## A quick check of GAS-II / cable / ADC125 linearity

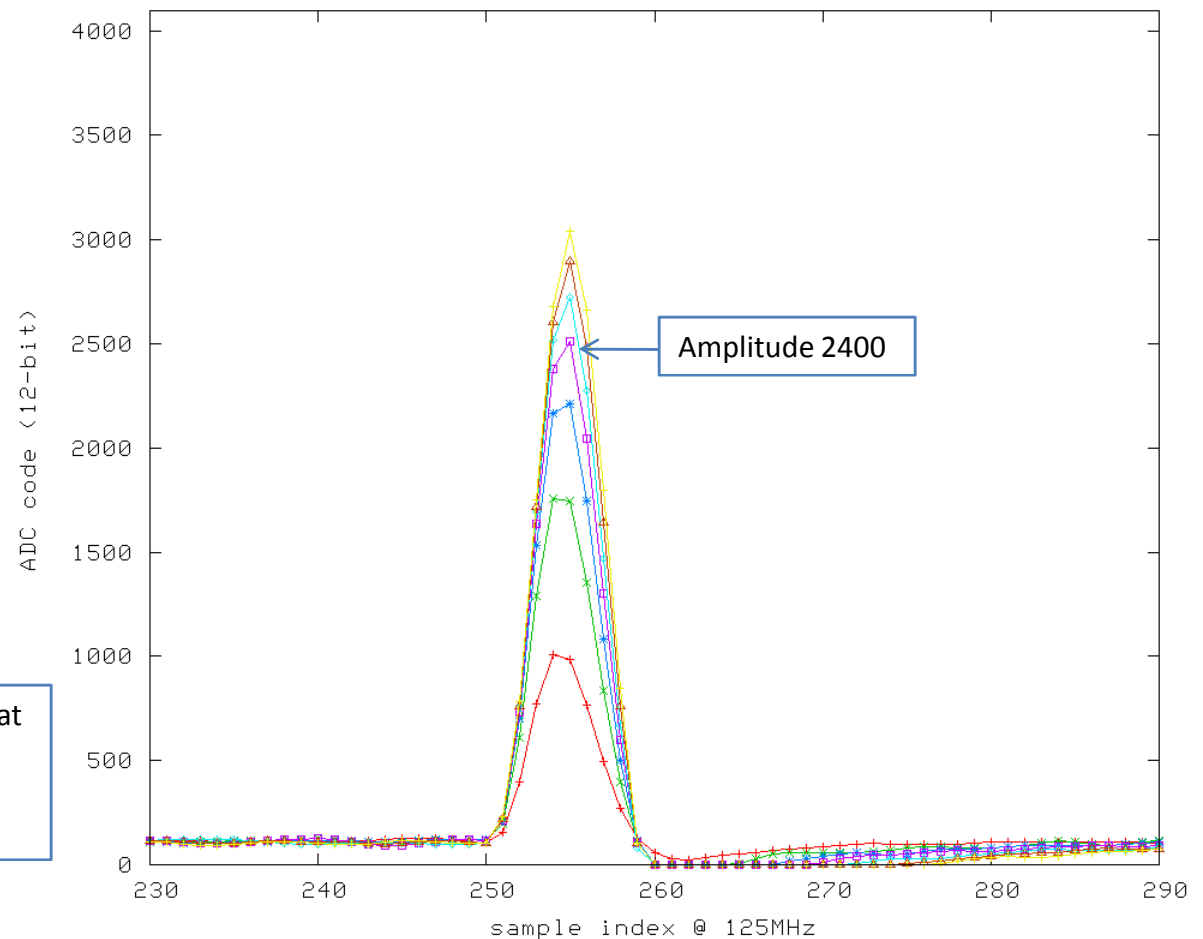
→ It certainly looks like we **should increase the gain of the ADC125** by about a factor of 2...

(Or better from a signal/noise standpoint, improve the linearity and output range of the ASIC, but too late for this now?)

Caveat: This measurement is on a preamp board that I have. It is set for cathodes, and I don't know the exact setup on it. The measurement should be repeated on a board setup for CDC usage.
